| Project | IEEE 802.16 Broadband Wireless Access Working Group < http://ieee802.org/16 > | |
| Title | Correct Figure for TEK management in BS and MS | |
| Re: | Response to Sponsor Ballot on IEEE802.16e/D8 document | |
| Abstract | This contribution corrects the figure for TEK management in BS and MS. | |

Figure 134—TEK management in BS and SS

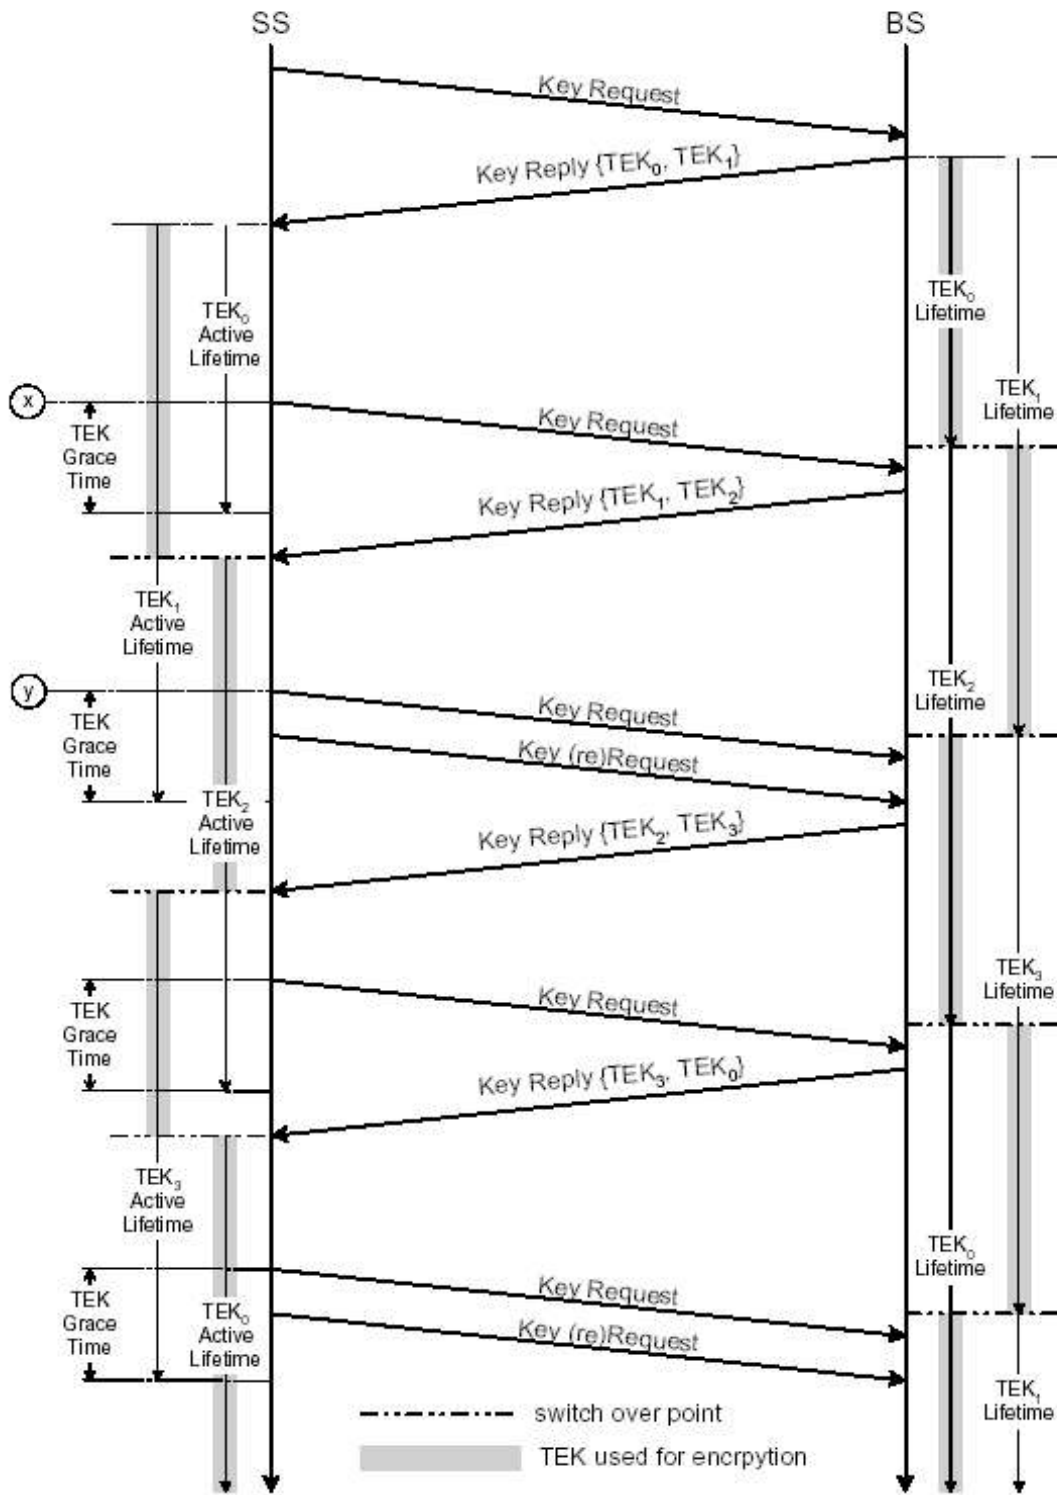
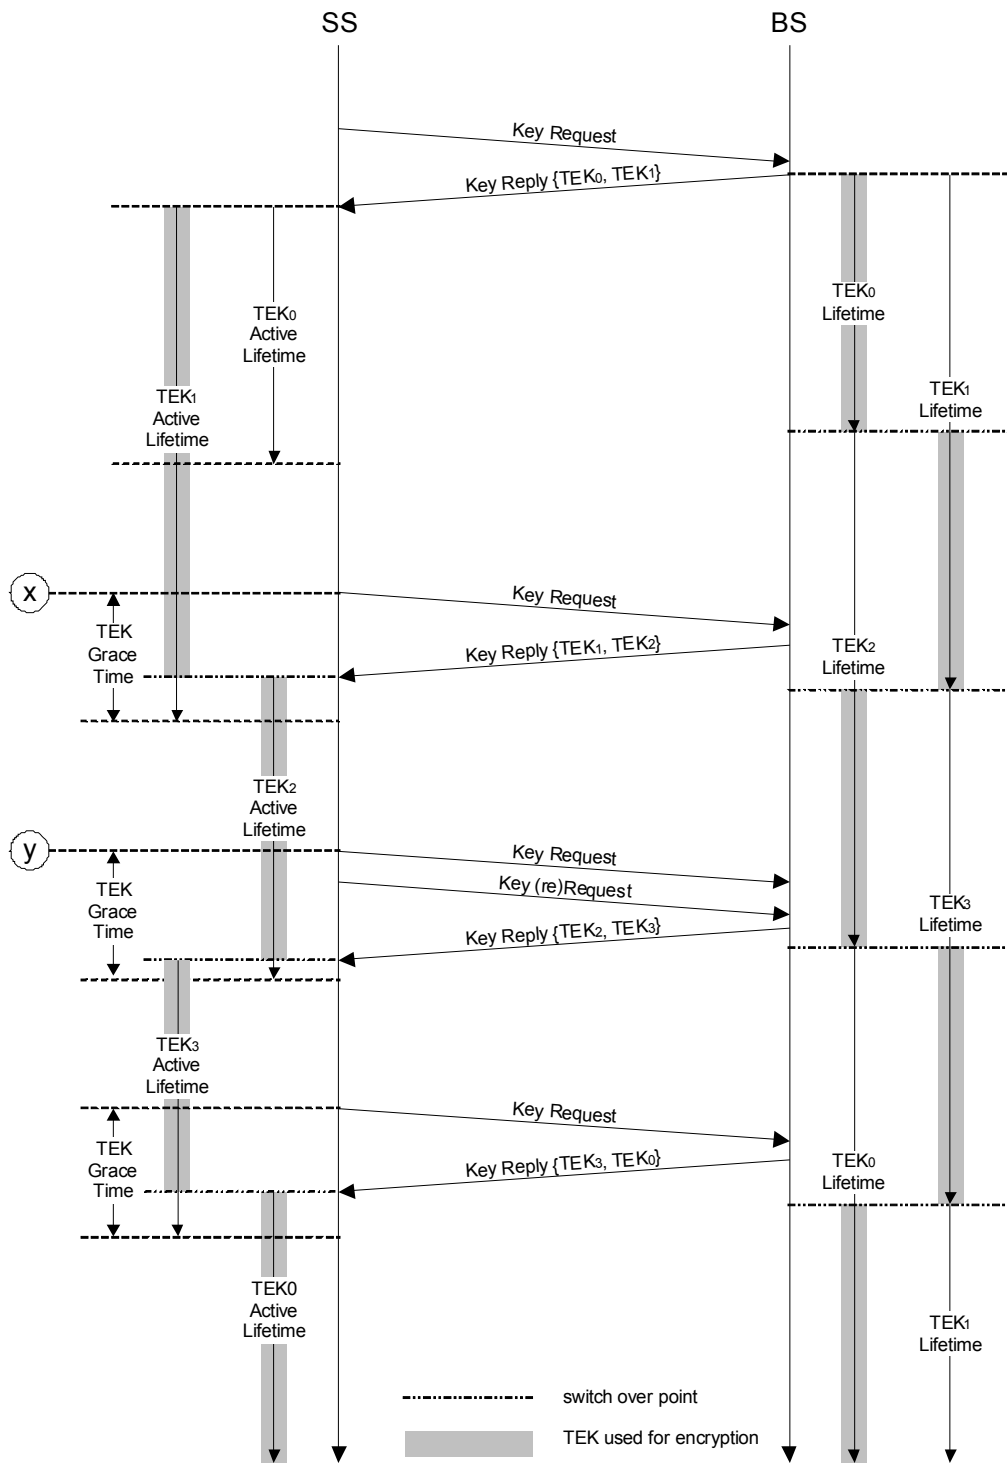
However, Figure 134 of 802.16-2004 is incorrect, **as the current figure shows that an SS sends Key Request message to the BS when TEK0 Refresh Timer is fired [see points (x)]. Also, it shows that the BS receives Key Request message after TEK0 Lifetime expires. Therefore, SS and BS cannot synchronize TEKs. Figure 134 of 802.16-2004 needs correction so it can comply with the texts in IEEE 802.16-2004.**

We propose a correct figure in the below. In the proposed figure, an SS sends Key Request message to the BS when TEK1 Refresh Timer is fired [see points (x)] and the BS receive Key Request message before TEK1 Lifetime expires.

[Replace Figure 134 of 802.16-2004 with a new figure:]
